Subject: Class 2 Permit Modification Request, Hazardous Waste Facility Permit Number:
NM4890139088-TSDF

Update Panel 8 Volatile Organic Compound Room-Based Limits

**Waste Isolation Pilot Plant
Carlsbad, New Mexico**

WIPP Permit Number - NM4890139088-TSDF

Figure A3-2
Typical Disposal Panel Dimensions for Panel 8

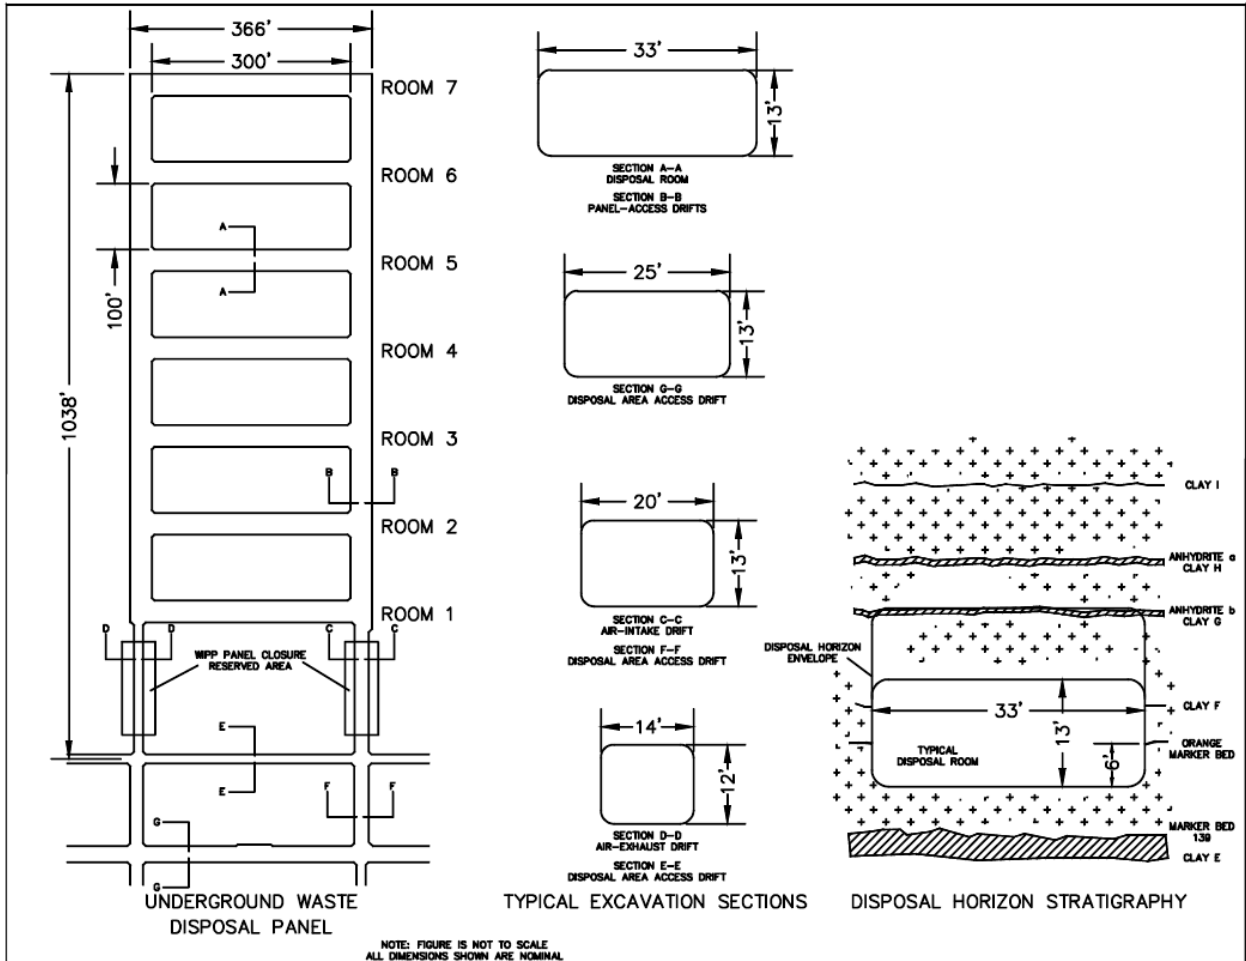
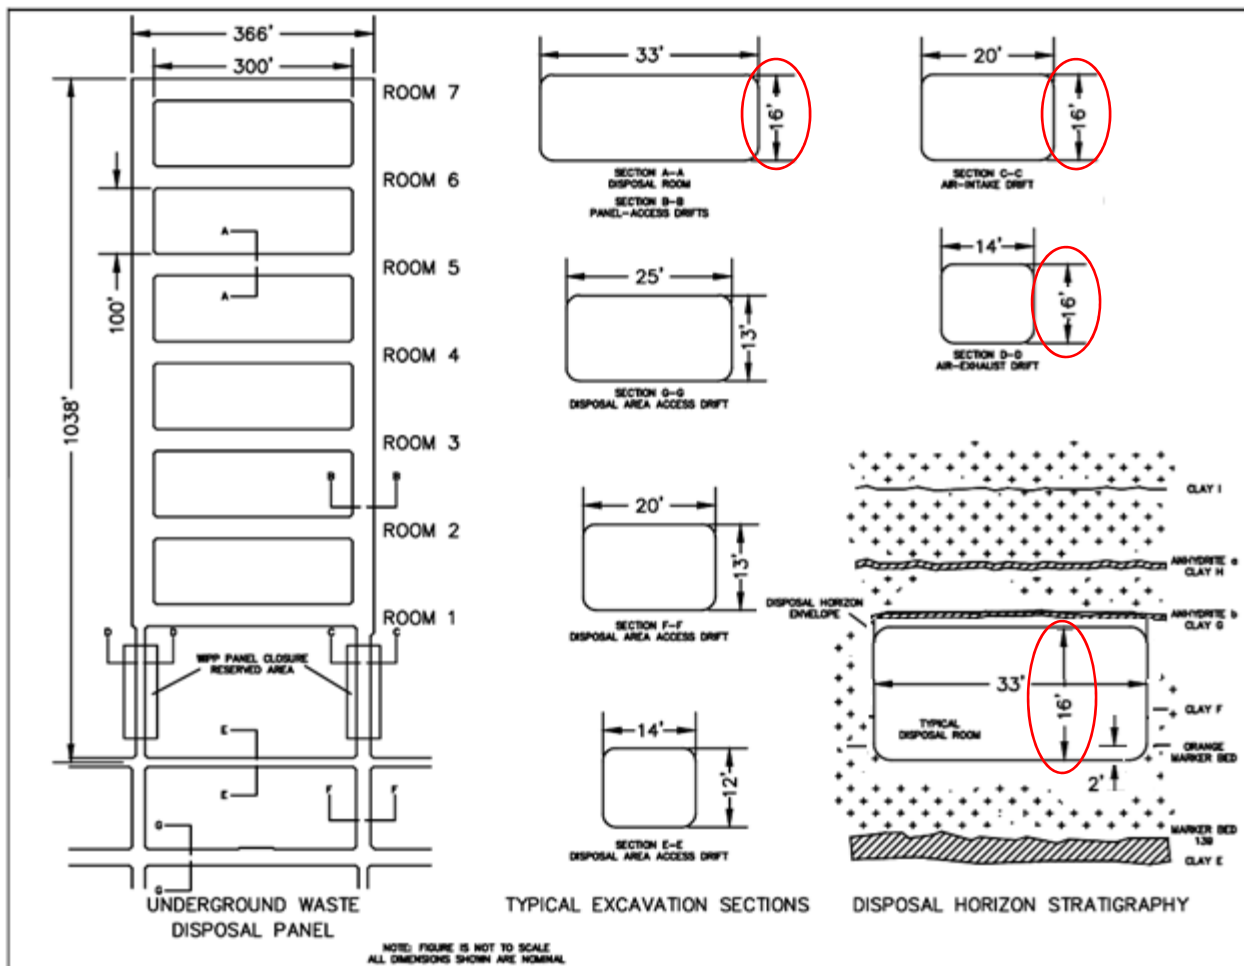
- Permit Attachment A3, *Typical Disposal Panel*.
 - Figure nomenclature is added to the existing figure along with a modification to the figure title. The modification reads as follows: “Figure A3-1, Typical Disposal Panel Dimensions for Panels 1-7”.

- A new figure, “Figure A3-2, Typical Disposal Panel Dimensions for Panel 8”, is added to illustrate the change in room height for Panel 8.
- Permit Attachment G, *List of Figures*.

| Affected Permit Section | Explanation of Change |
|--|---|
| Permit Attachment A3, <i>Typical Disposal Panel</i> . | Added figure nomenclature to the existing figure: "Figure A3-1, Typical Disposal Panel Dimensions for Panels 1-7". |
| | Added Figure A3-2, Typical Disposal Panel Dimensions for Panel 8. |

Figure G-5b
Typical Disposal Panel Dimensions for Panel 8

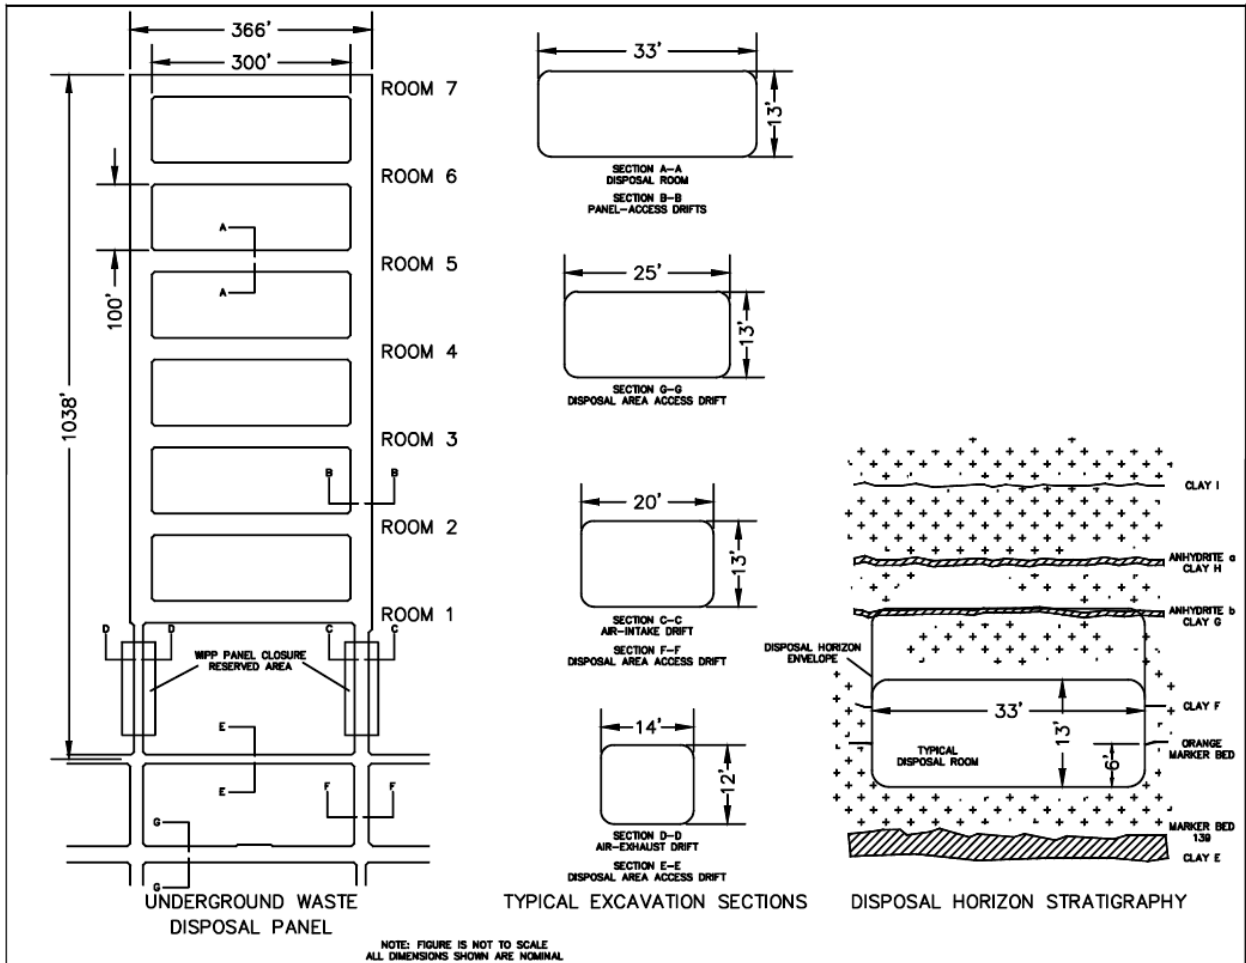
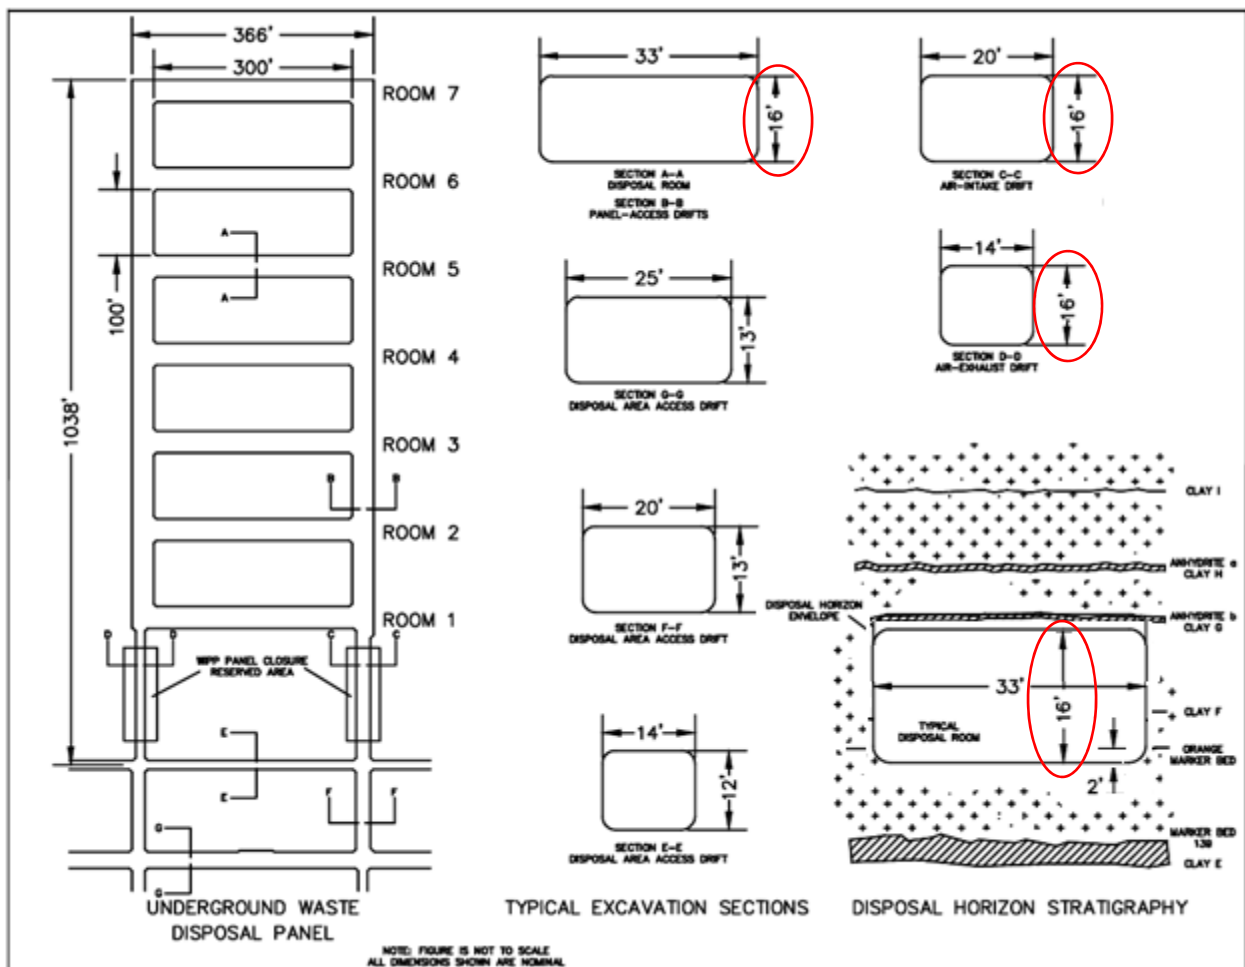
- The existing figure, Figure G-5, is being separated into two figures, Figure G-5a and Figure G-5b to differentiate between Panels 1-7, and Panel 8, respectively.

- Permit Attachment G, *Figures*.
 - The existing figure title of Figure G-5 is modified from “Figure G-5, Typical Disposal Panel,” to, “Figure G-5a, Typical Disposal Panel Dimensions for Panels 1-7”

- A new figure, “Figure G-5b, Typical Disposal Panel Dimensions for Panel 8”, is added to illustrate the change in room height for Panel 8.

| Affected Permit Section | Explanation of Change |
|--|---|
| Permit Attachment G, <i>Figures</i> . | Modified the existing title of Figure G-5 from, "Figure G-5, Typical Disposal Panel," to, "Figure G-5a, Typical Disposal Panel Dimensions for Panels 1-7". |
| | Added Figure G-5b, Typical Disposal Panel Dimensions for Panel 8. |

Figure N-4b
Disposal Room Sample Head Arrangement for Panel 8

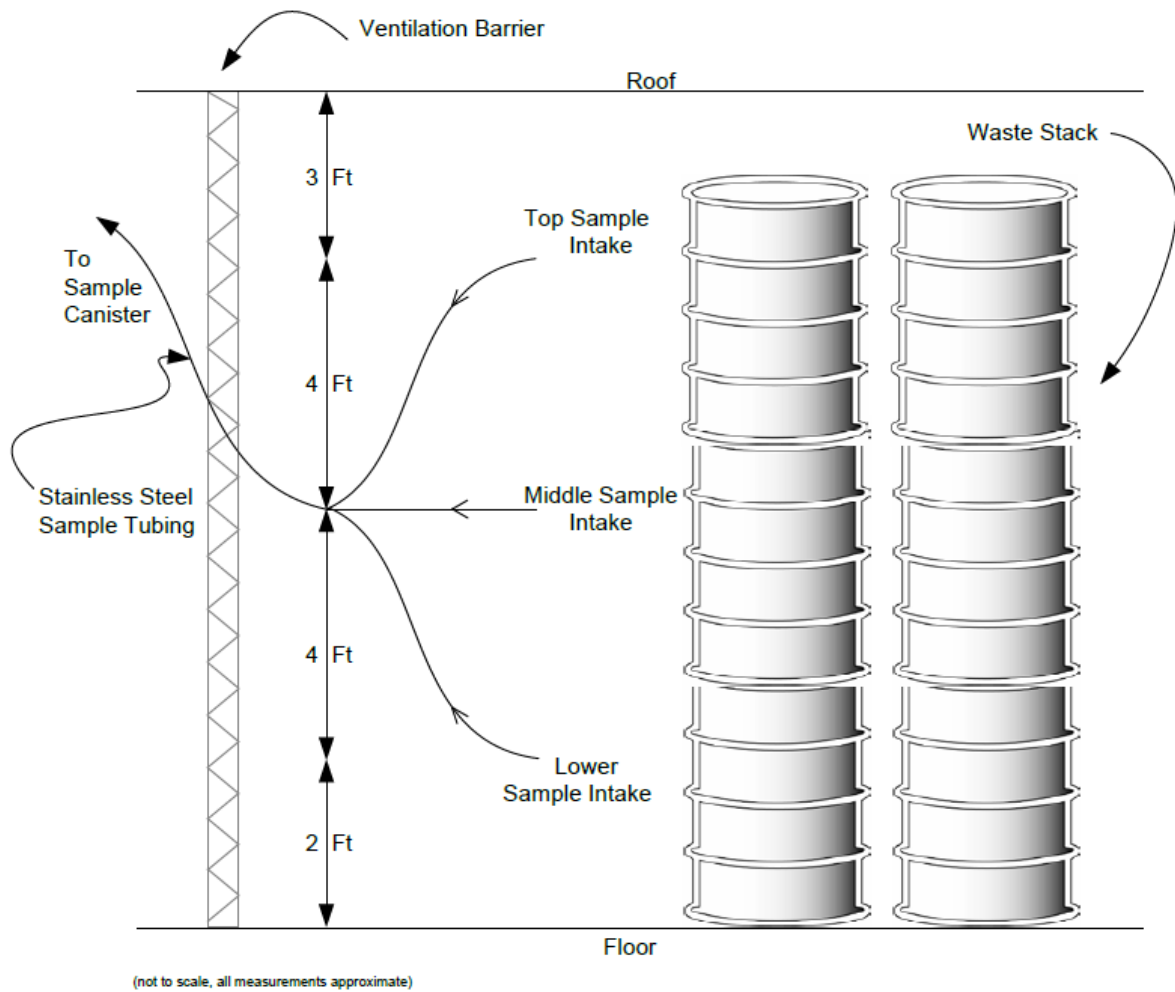
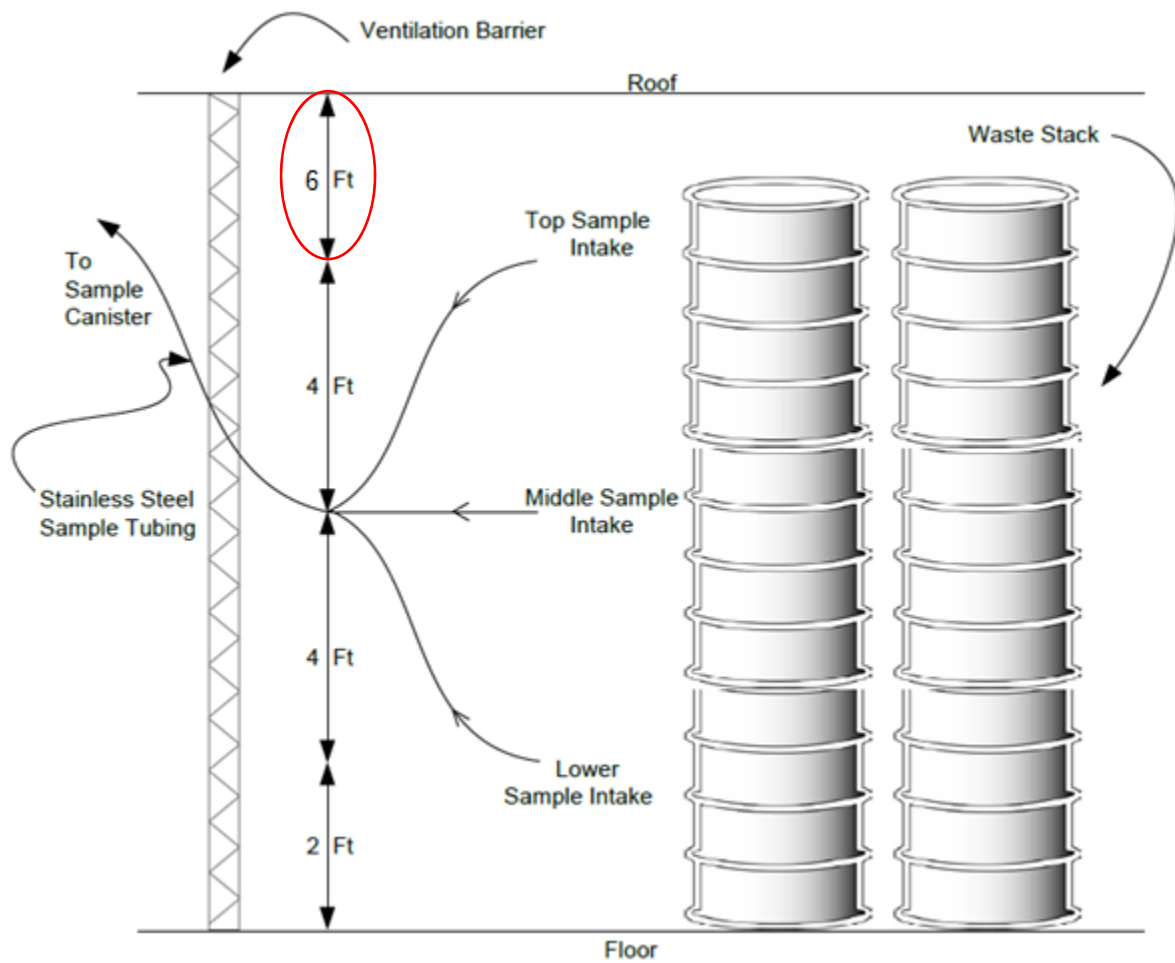
- Permit Attachment N, *List of Figures*.
 - The existing figure, Figure N-4, is being separated into two figures, Figure N-4a and Figure N-4b to differentiate between Panels 1-7, and Panel 8, respectively.

- Permit Attachment N, *Figures*.
 - The existing figure title of Figure N-4 is modified from “Figure N-4, Disposal Room Sample Head Arrangement,” to, “Figure N-4a, Disposal Room Sample Head Arrangement for Panels 1-7”.

- A new figure, “Figure N-4b, Disposal Room Sample Head Arrangement for Panel 8”, is added to illustrate the change in room height for Panel 8.

| Affected Permit Section | Explanation of Change |
|---|---|
| Permit Attachment N, <i>Figures</i> . | Modified Figure N-4 from, "Figure N-4, Disposal Room Sample Head Arrangement," to, "Figure N-4a, Disposal Room Sample Head Arrangement for Panels 1-7" |
| | Added Figure N-4b, Disposal Room Sample Head Arrangement for Panel 8. |

Figure C-9: Panel 8 Room Dimensions

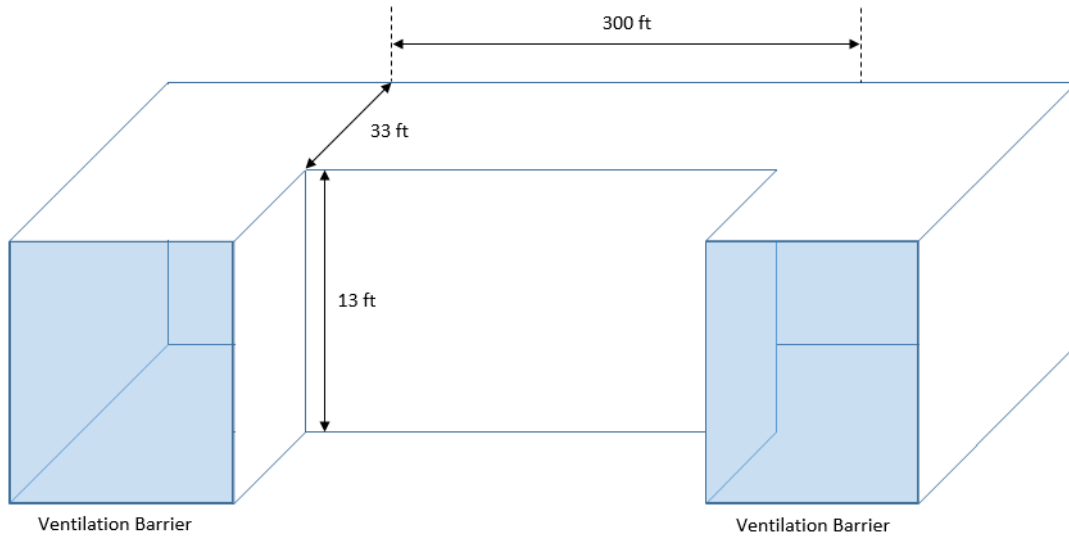
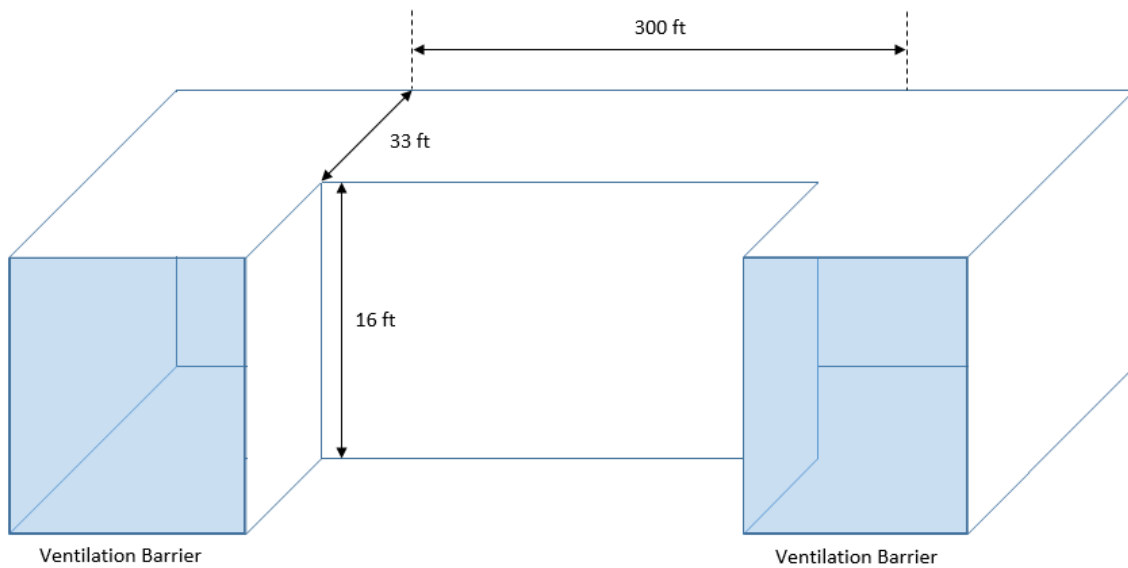
The same hypothetical adjacent closed room scenario and calculation methodology is used to determine the VOC room-based limits for Panel 8. The parameters previously discussed remain the same with the exception of the disposal room height. For Panel 8, the room height will be 16 ft instead of 13 ft, as in the original design. To provide an equivalent level of protection to the worker in the active room, the VOC room-based limits for Panel 8 are changed accordingly.

Because the Panel 8 room height dimension is larger than the original panel design, the room headspace volume in the adjacent closed room increases from 1.5 feet to 4.5 feet. This increases the room headspace volume (**RHV**), which will change the health-based VOC room-based limits for Panel 8. Figure C-10 illustrates the modified scenario.
